Safety Evaluation Report

Related to the License Renewal of the Virgil C. Summer Nuclear Station

Docket No. 50-395

South Carolina Electric & Gas Company

**Figure 1: Wear Degradation of Components in the Extraction Steam System:
Theory vs. Actual**

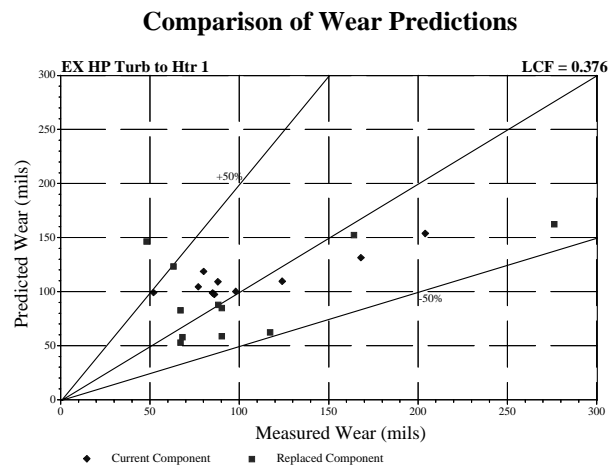
RAIs B.1.6-2 and B.1.6-3, the applicant to list those systems, within the program's scope, most susceptible to FAC. The staff also requested a sample list of components susceptible to FAC with each component's initial, current, and future predicted wall thicknesses, to demonstrate the effectiveness of the Flow-Accelerated Corrosion Monitoring Program. In its response dated June 12, 2003, the applicant stated that the Flow-Accelerated Corrosion Monitoring Program will detect loss of material due to FAC prior to the loss of component intended function. The applicant referenced the October 1992 NRC Inspection Report 50-395/92-20, which stated, "The licensee has established an effective program to maintain high energy carbon steel piping systems within acceptable wall thickness limits." The staff finds that while the referenced inspection report affords some assurance of the effectiveness of the Flow-Accelerated Corrosion Monitoring Program, the report did not supply the information sought by the staff. Therefore, the staff requested a list of those systems, within the program scope, and the components most susceptible to FAC, in addition to the initial, current, and future predicted wall thicknesses, to demonstrate the effectiveness of the Flow-Accelerated Corrosion Monitoring Program.

In subsequent correspondence dated September 2, 2003, the applicant discussed the integration of prediction and inspection inherent in its FAC program. The applicant stated the system most susceptible to FAC at VCSNS is the extraction steam system. This conclusion has been confirmed by the applicant's predictive model and the as-found ultrasonic data for many components. The predictive model of record (CHECWORKS™) represents an analysis tool used by the applicant in the selection of problem areas. This model also aids in the inspection scheduling process. Over time, the applicant determined that model predictions with as-found ultrasonic data have returned reasonable agreement. The applicant provided an example of the predicted vs. measured wear comparisons for components in the extraction steam system summarized below.
